Re:FCC ID QLA500MHZ
Applicant: Mala GeoScience AB (publ)
Correspondence Reference Number: 24229
731 Confirmation Number: EA369105

Figure 1. Pulse characteristic of a 500 MHz UWB-unit.

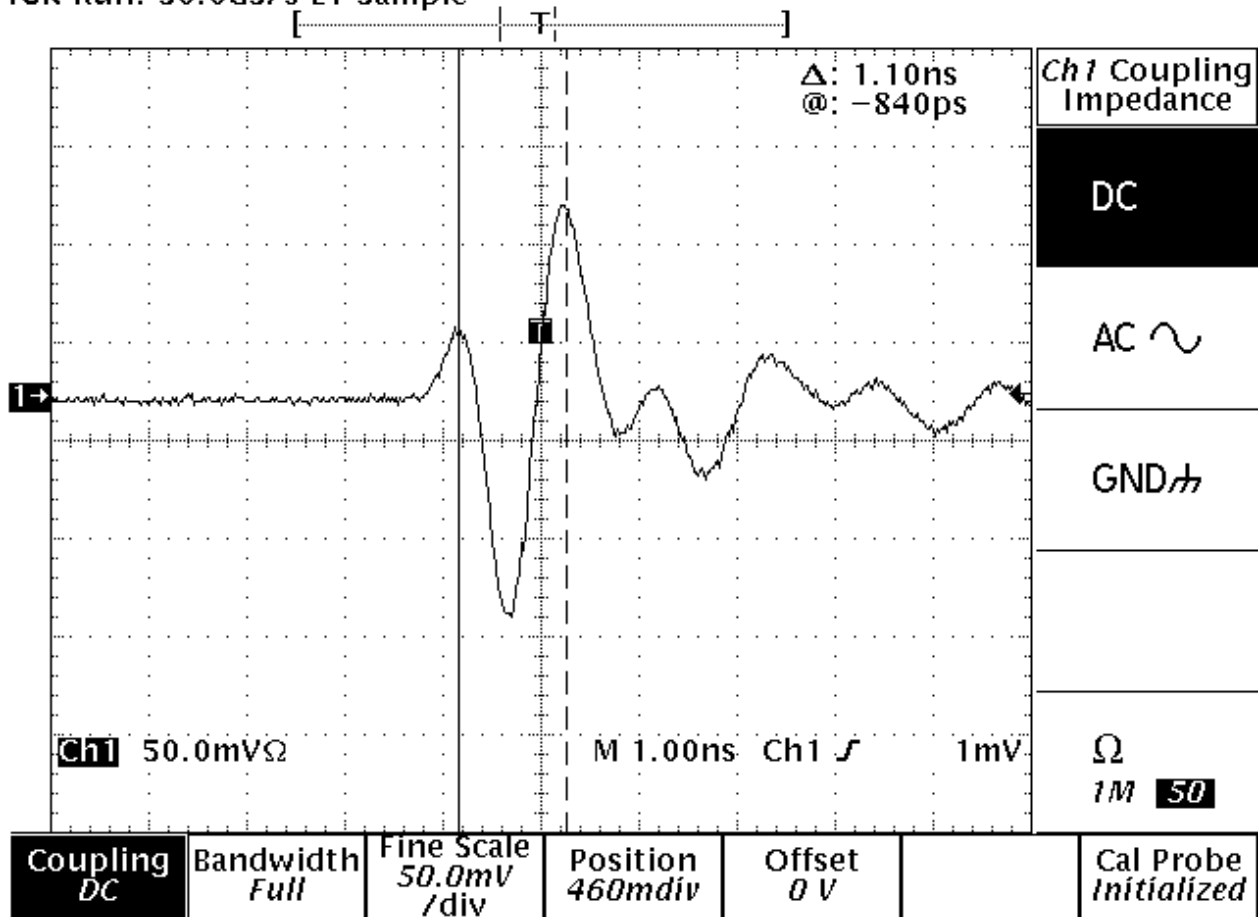
9) What is the pulse width of this device. Is the pulse random (dithered) or periodic? Upload an exhibit with the pulse characteristics of this device. Include a plot.

The 500 MHz UWB-unit has a pulse width of about 1 ns, in air. A plot of the pulse is shown in figure 1 below. The pulse is periodic with a repetition frequency of 100 kHz.
